SUBJECT: GRAND GULF NUCLEAR STATION, UNIT 1 - STAFF ASSESSMENT OF INFORMATION PROVIDED PURSUANT TO TITLE 10 OF THE CODE OF FEDERAL REGULATIONS PART 50, SECTION 50.54(f), SEISMIC HAZARD REEVALUATIONS FOR RECOMMENDATION 2.1 OF THE NEAR-TERM TASK FORCE (NTTF) REVIEW OF INSIGHTS FROM THE FUKUSHIMA DAI-ICHI ACCIDENT AND STAFF CLOSURE OF ACTIVITES ASSOCIATED WITH NTTF RECOMMENDATION 2.1, "SEISMIC" (TAC NO. MF3750)

STAFF ASSESSMENT BY THE OFFICE OF NUCLEAR REACTOR REGULATION

RELATED TO SEISMIC HAZARD AND SCREENING REPORT

GRAND GULF NUCLEAR STATION, UNIT 1

Figure 3.3-1 Plot of Staff's and Licensee's Base Case Shear-Wave Velocity Profiles for the GGNS Site

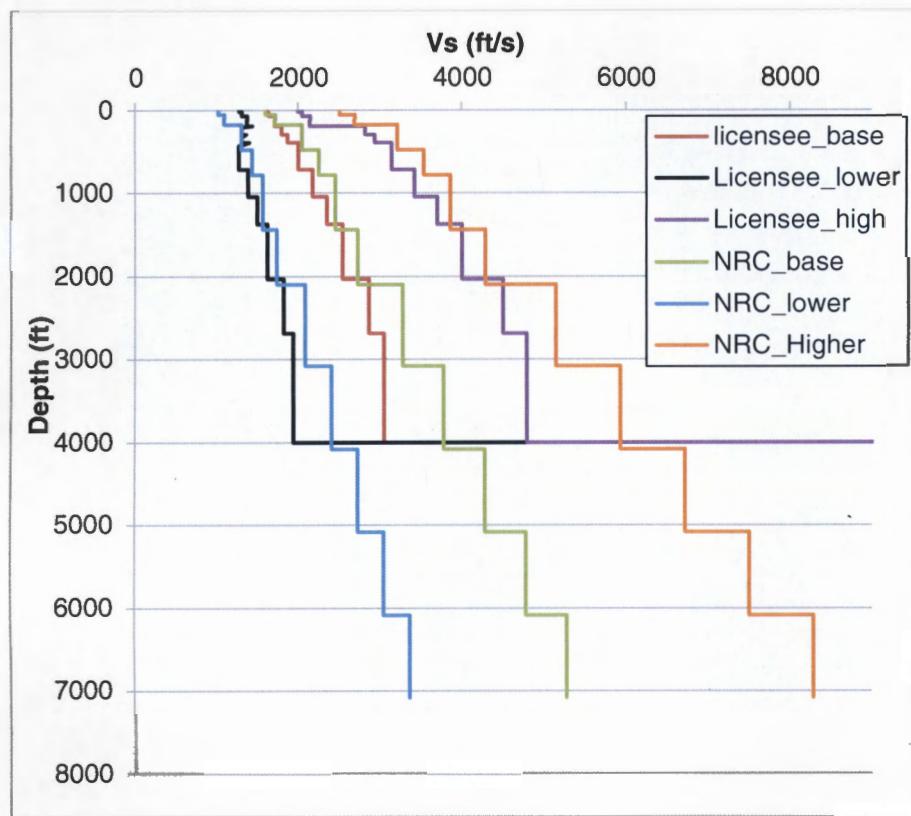
terminated its profile at 4,000 ft. (1,219 m) because shear wave velocity variations at depths greater than 4,000 ft. (1,219 m) are expected to have little impact on the site response at frequencies above the 0.5 Hz minimum defined by the GMM. To capture the uncertainty in the subsurface shear wave velocities, the licensee developed lower and upper base case velocity profiles using a scale factor of 1.25 over the upper 190 ft. (58 m) and a scale factor of 1.57 over the remainder of the profile. These values are consistent with a natural log standard deviation of 0.2 and 0.35 for the upper and lower portions of the profiles, respectively. Figure 3.3-1 of this assessment shows the licensee's three base case shear-wave velocity profiles.

The GGNS site condition is relatively well characterized due to the extensive geotechnical work implemented during subsurface investigations conducted as part of the ESP application. Geotechnical investigations included the drilling of boreholes, P-S logging, resonant column and torsional shear (RCTS) analyses, and other geotechnical studies of the shallow subsurface. Additionally, the ESP applicant correlated this new data with data collected during initial licensing of the operating plant, demonstrating consistency in the subsurface between the two sites. As a result, the NRC staff relied on UFSAR data, obtained during original licensing, to develop the shear wave velocities for the upper portion of the profile and used ESP data to extend the site profile to about 3,000 ft. (914 m) depth. The NRC staff extended the profile to a total depth of 7,000 ft. (2,134 m) using the shear wave velocity gradient recommended in the SPID. Specifically, the upper 200 ft. (61 m) of the shear wave velocity profile is based on UFSAR Table 2.1-6.6 and the remainder of the profile is based on Figure 2.5-61 of SSAR of the ESP application. To account for the variability in shear wave velocities beneath the site, the NRC staff developed lower and upper profiles using a natural log standard deviation of 0.2. Figure 3.3-1 of this assessment shows a comparison of the three base case profiles developed by the licensee with those developed by the NRC staff. The profiles developed by the NRC staff are generally similar to those developed by the licensee over the total depth of the profile. Differences between the two sets of profiles result from the staff's use of a slightly higher velocity gradient and the total thicknesses of the profiles as the profiles developed by the NRC staff extend to a greater depth than those developed by the licensee.

Figure 3.3- 2 Plot Comparing the Staff's and the Licensee's Median Amplification Functions and Uncertainties for the GGNS site.

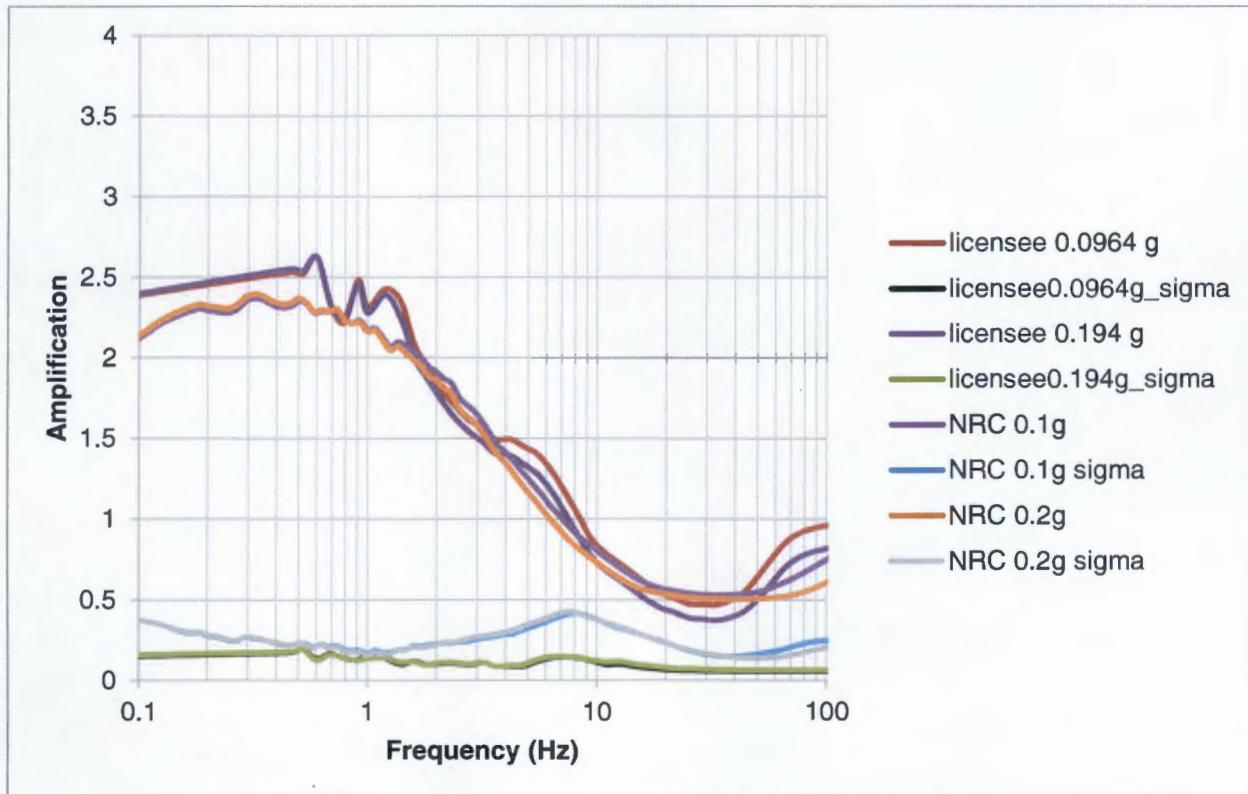
Figure 3.3-2 of this assessment shows a comparison of the staff's and the licensee's median site amplification functions and uncertainties (± 1 standard deviation) for two of the eleven input loading levels. Amplification functions developed by the NRC staff and by the licensee peak at a value of 2-2.5 between 0.1 to 1 Hz. Differences in the site amplification curves developed by the NRC staff and the licensee are very minor and are due to the minor differences in the site velocity profiles. As shown in Figure 3.3-3 of this assessment, these differences, and differences in PSHA inputs have a modest impact on control point seismic hazard curves and the resulting GMRS, discussed below. Appendix B of the SPID provides guidance for performing site response analyses, including capturing the uncertainty for sites with less subsurface data. However, the guidance is neither entirely prescriptive nor comprehensive. As such, various approaches in performing site response analyses, including the modeling of uncertainty, are acceptable for the 50.54(f) response.

Figure 3.3-3 Plot Comparing the Staff's and the Licensee's Mean Control Point Hazard Curves at a Variety of Frequencies for the GGNS site

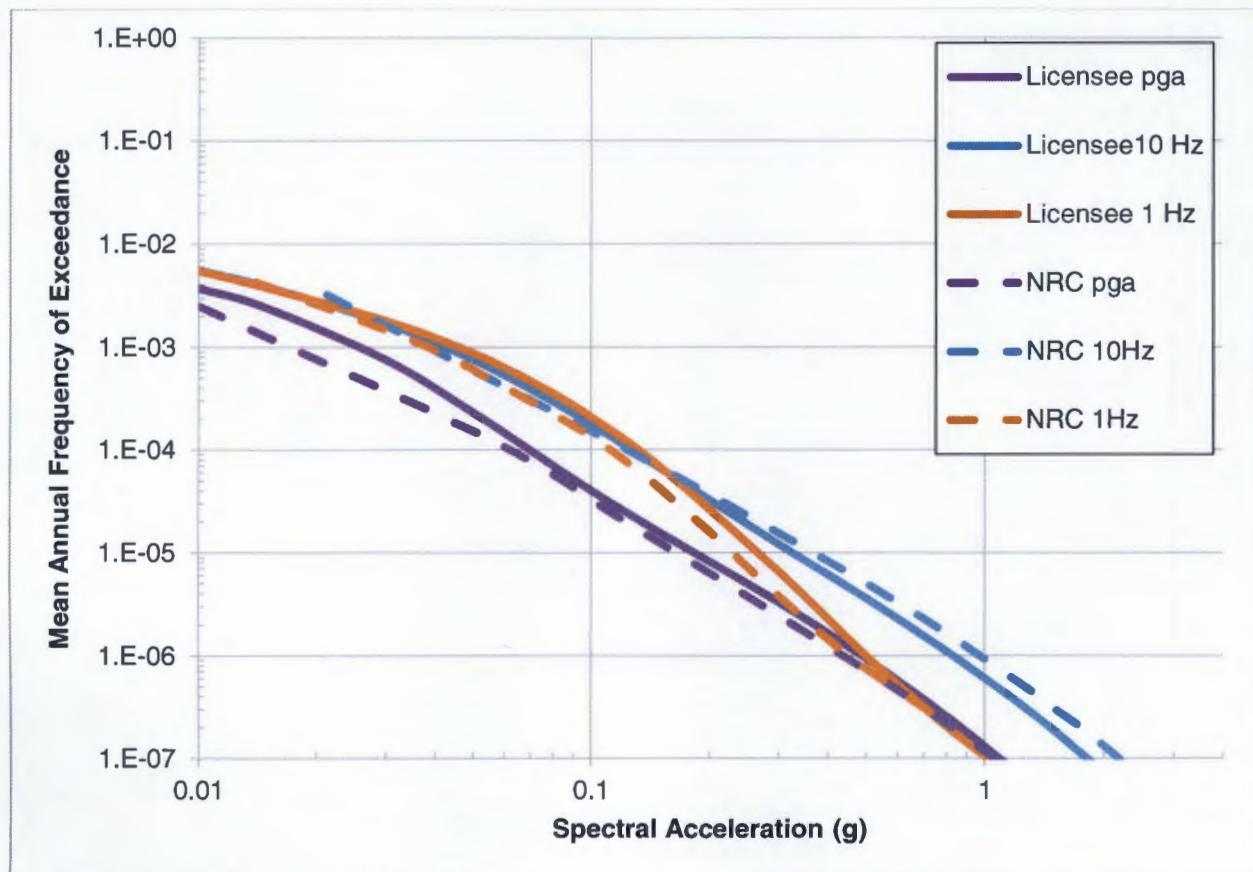
In summary, the NRC staff concludes that the licensee's site response was conducted using present-day guidance and methodology, including the NRC-endorsed SPID. The NRC staff performed independent calculations to confirm that the licensee's amplification factors and control point hazard curves adequately characterize the site response, including the uncertainty associated with the subsurface material properties, for the GGNS site.

Figure 3.4-1 Comparison of the Staff's GMRS with Licensee's GMRS and the SSE for the GGNS site

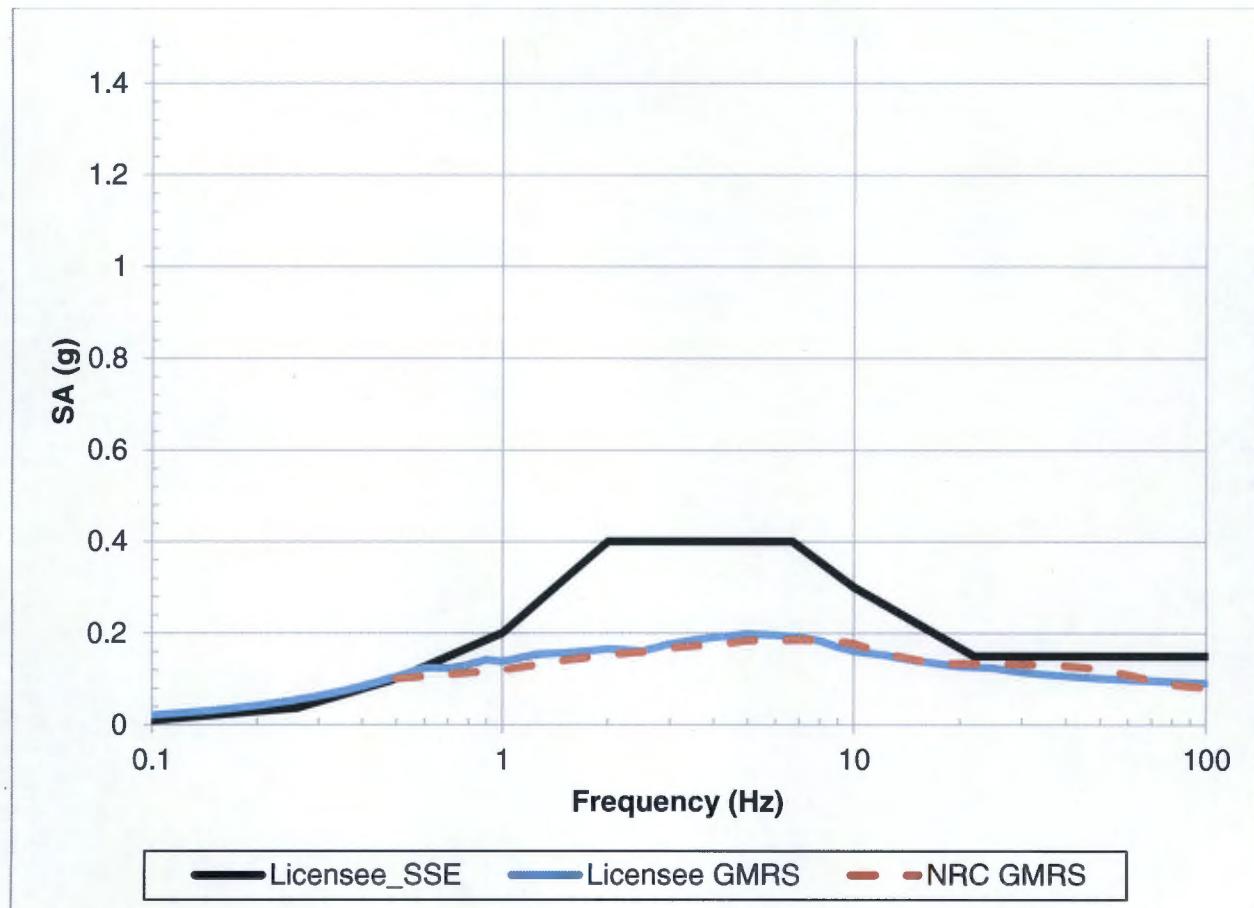
As shown in Figure 3.4-1 of this assessment, the licensee's GMRS shape is very similar to that calculated by the NRC staff. At frequencies where the amplitude of the GMRS determined by the licensee is different from that determined by the NRC staff, the licensee's generally exceeds that of the NRC staff. These differences in GMRS are the result of differences in the site response analyses and in the PSHA performed by the licensee and NRC staff, as discussed above.

The NRC staff confirms that the licensee used the present-day guidance and methodology outlined in RG 1.208 and the SPID to calculate the horizontal GMRS, as requested in the 50.54(f) letter. The NRC staff performed both a PSHA and site response confirmatory analysis and achieved results consistent with the licensee's horizontal GMRS. As such, the NRC staff concludes that the GMRS determined by the licensee adequately characterizes the reevaluated hazard for the GGNS site. Therefore, this GMRS is suitable for use in subsequent evaluations and confirmations, as needed, for the licensee's response to the 50.54(f) letter.
